Peach Bottom Atomic Power Station, Units 2 and 3
Renewed Facility Operating License Nos. DPR-44 and DPR-56
NRC Docket Nos. 50-277 and 50-278

Subject: Application to Revise Technical Specifications to Adopt TSTF-523, "Generic Letter 2008-01, Managing Gas Accumulation," Revision 2, using the Consolidated Line Item Improvement Process

SR 3.5.3.2

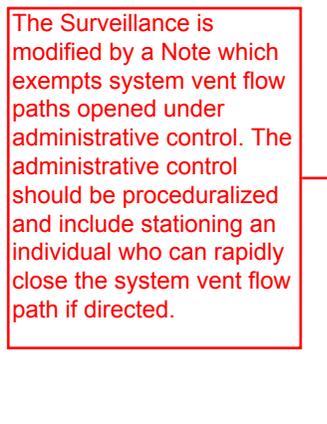
Verifying the correct alignment for manual, power operated, and automatic valves in the RCIC flow path provides assurance that the proper flow path will exist for RCIC operation. This SR does not apply to valves that are locked, sealed, or otherwise secured in position since these valves were verified to be in the correct position prior to locking, sealing, or securing. A valve that receives an initiation signal is allowed to be in a nonaccident position provided the valve will automatically reposition in the proper stroke time. This SR does not require any testing or valve manipulation; rather, it involves verification that those valves capable of potentially being mispositioned are in the correct position. This SR does not apply to valves that cannot be inadvertently misaligned, such as check valves. For the RCIC System, this SR also includes the steam flow path for the turbine and the flow controller position.

The Surveillance is modified by a Note which exempts system vent flow paths opened under administrative control. The administrative control should be proceduralized and include stationing an individual who can rapidly close the system vent flow path if directed.
